CONNECTION ASSESSMENT & APPROVAL PROCESS

*Project: MacKay TS
Installation of a Generation Rejection Scheme*

CAA ID No. 2002-EX074

MACKAY TS - Install Generation Rejection Scheme

DIAGRAM 1

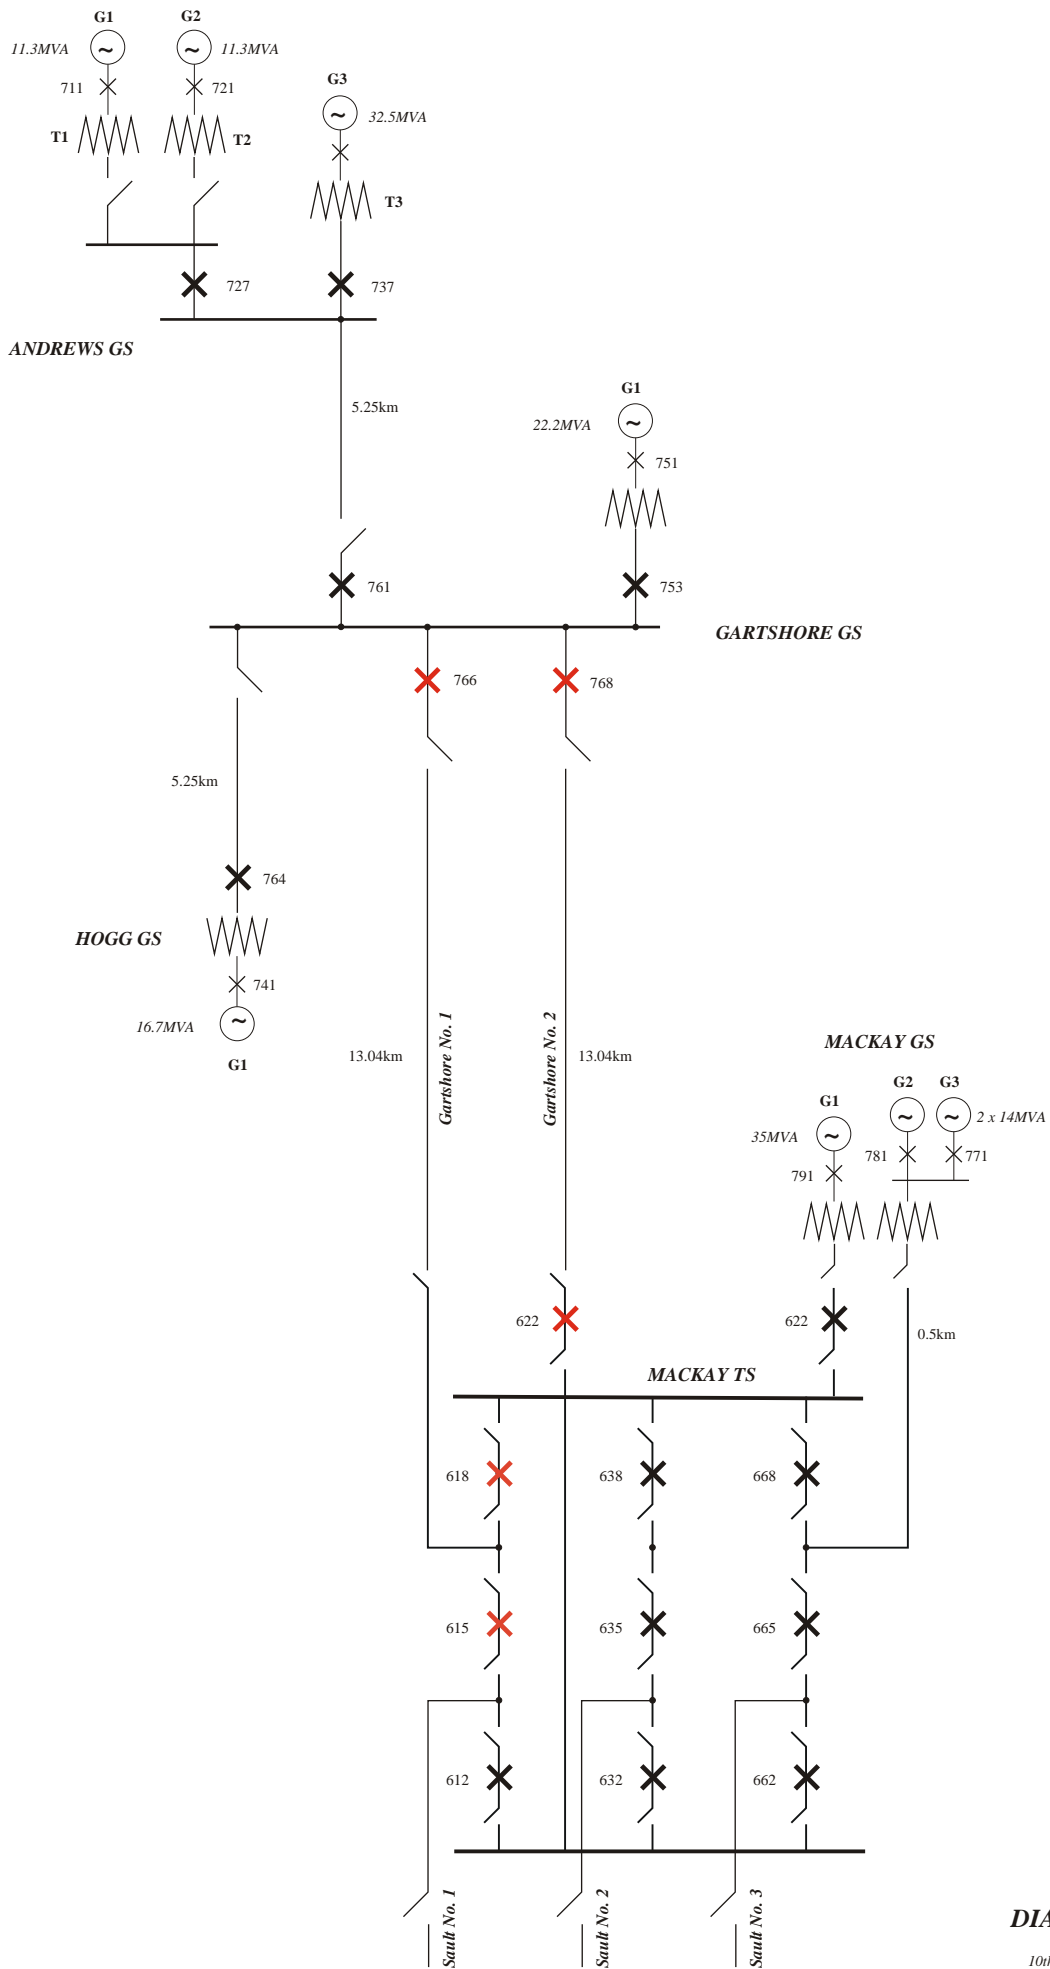
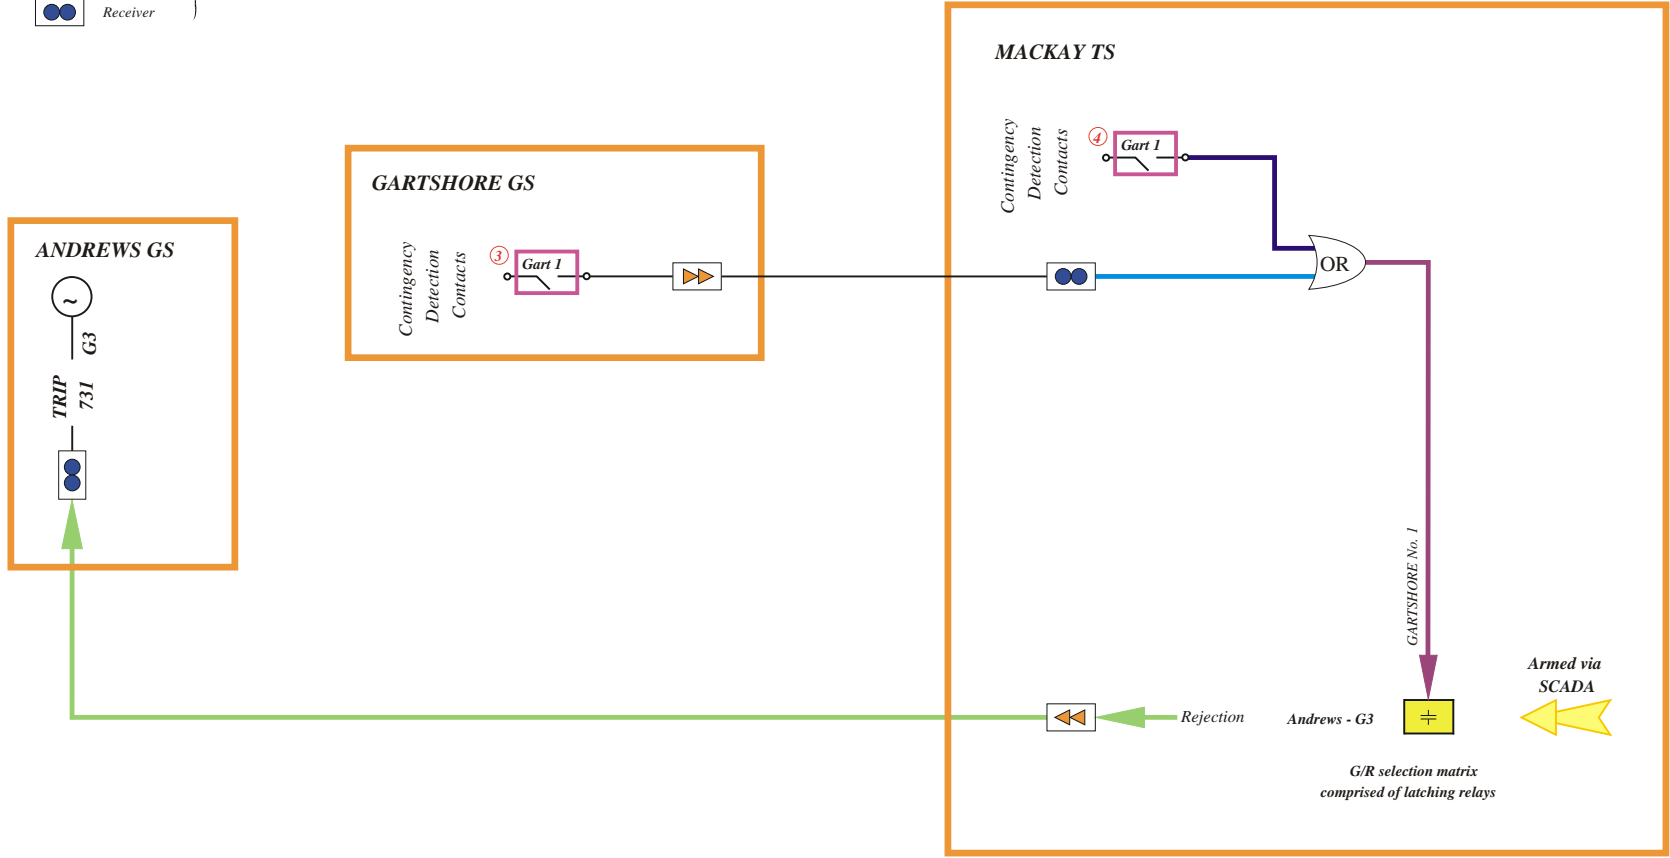
The following four generating stations are presently in operation on the Montreal River and incorporated via the 115kV system into MacKay TS, as shown in Diagram 1:

The two Gartshore circuits, Nos 1 & 2, have continuous summertime ratings of approximately 100MVA and 60MVA, respectively. However, since the combined capacity of the generating facilities incorporated via these two circuits totals approximately 94MVA, a contingency involving the Gartshore No. 1 circuit would result in the continuous rating of the lower-rated No. 2 circuit being exceeded.

DIAGRAM 3

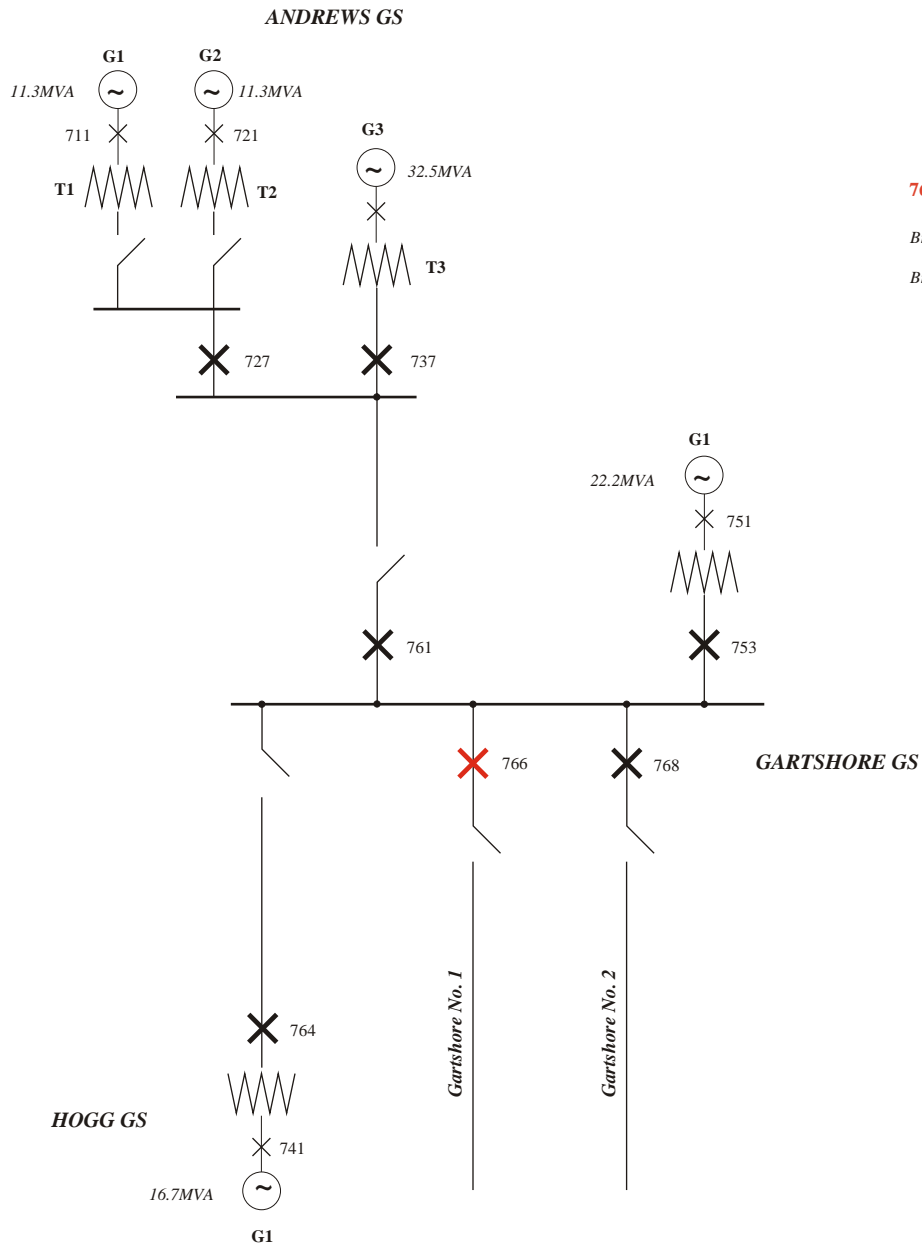
Diagrams 3 & 4 provide the details of the ‘contingency detection facilities’ that are to be installed at Gartshore GS and MacKay TS, respectively. These facilities are to be duplicated.

- The G/R Scheme must be fully duplicated (this includes contacts, relays, communications and batteries).
 - If latching relays are used, then since their status is to be monitored and any discrepancy will be alarmed, these do not need to be duplicated.
 - However, if PLCs are used, these must be duplicated with discrepancy monitoring installed on the PLCs.
- The status of the latching relay, or PLCs is to be telemetered to the IMO.
- The contingency detection facilities must use contacts from the breaker trip modules (to enhance the speed of operation of the generation rejection) as well as from the breaker pallet switches.
